**WOKINGHAM
BOROUGH COUNCIL**

Approval of Reserved Matters Consultation

Application Number: 252379

Site Address: Parcel N, Arborfield Green, Berkshire

Public Transport Strategy

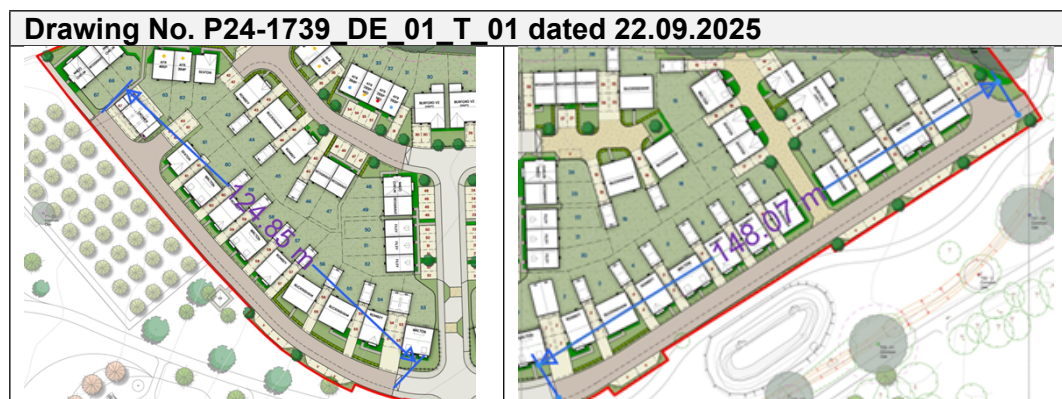
2. The LHA have no objection to the public transport strategy. The WBC Public Transport officers have been consulted and have no objection.

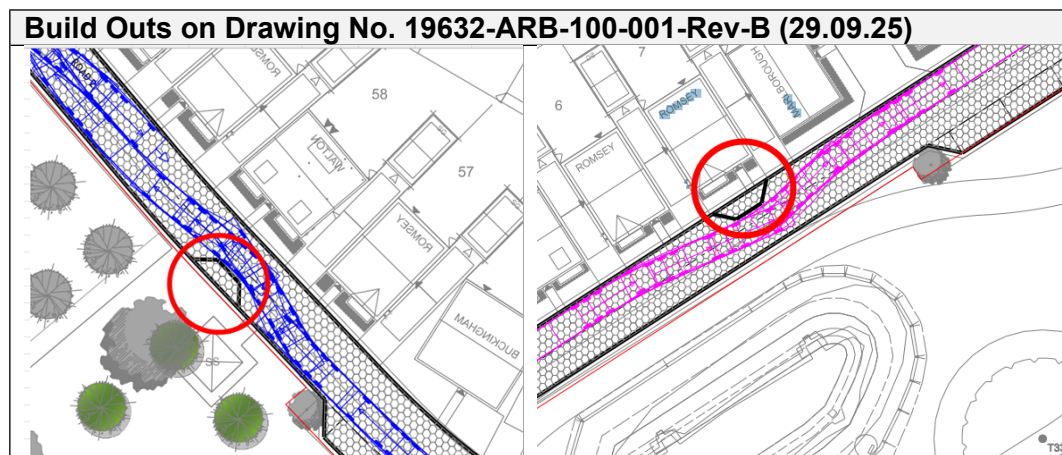
3. The Wokingham Living Streets Guide (2019) requires a 20mph design speed on roads within new developments. The street design should naturally convey a 20mph speed. The LHA require traffic calming features on the two spine roads which splay east and west on the site layout plan. These spine roads are c.120m - 150m long roads which are almost straight. There is concern residents and delivery drivers will exceed the 20mph design speed unless

vertical or horizontal features are introduced which will result in traffic calming.

4. DfT LTN1/07 Traffic Calming advises that *'Speed control measures should be spaced at about 60 to 70 metres apart but not more than 50 metres from any given point unless on cul-de sacs less than 80 metres long...this spacing of traffic calming measures should ensure that the zone is self-enforcing (i.e. vehicle speeds are kept at least at or below an average of 20mph' (Paragraph 3.2.17).*
5. Screenshots are provided below highlighting the areas of concern:

6. The screenshots above appear contrary to the swept path analysis drawings which show build outs on both the western and eastern spine roads.

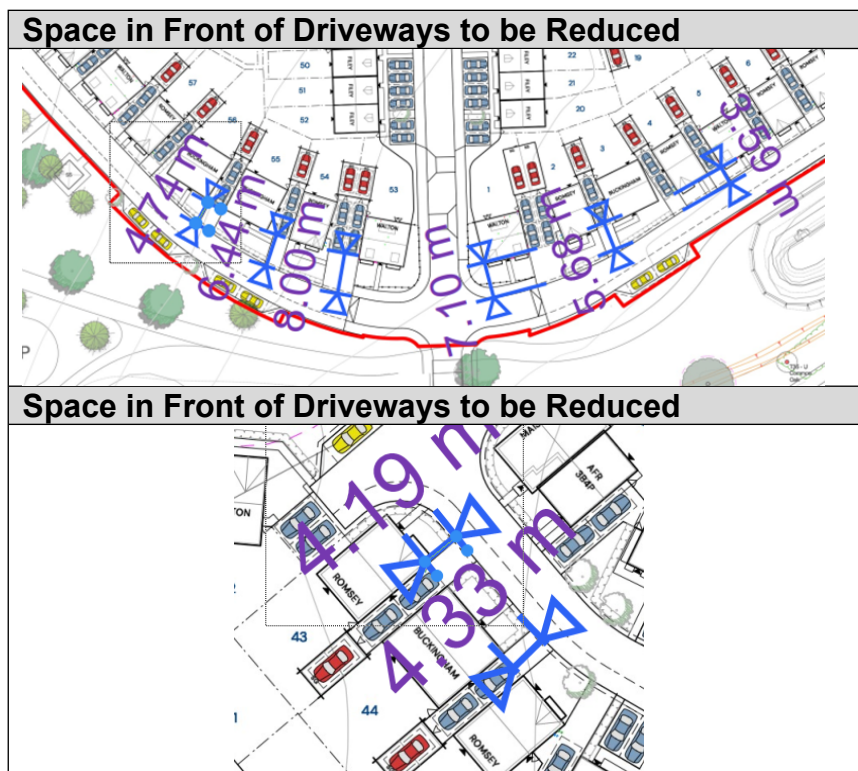
9. The LHA require 14 visitor car parking spaces are provided in accordance with the requirements of the WBC Parking Standards for 67 dwellings. The WBC Car Parking Standards outline in Paragraph 5.13.7 that: *'Developers should also include for visitor parking, which is calculated for all dwellings that have 1 or more allocated space on the basis of 0.2 per dwelling'*

10. 14 Car Parking Spaces are shown within the application red line. However, it is understood that the landscape architect requires the relocation of the visitor parking spaces adjacent to the linear park. Therefore, the LHA require these visitor spaces to be relocated to different areas within the application red line.

11. It would not be acceptable to remove these spaces entirely from the site layout because the number of visitor spaces would then fall below the requirements of the adopted WBC Car Parking Standards and there would be the risk of visitors parking dangerously blocking footways, turning heads or visibility splays to the detriment of public highway safety.
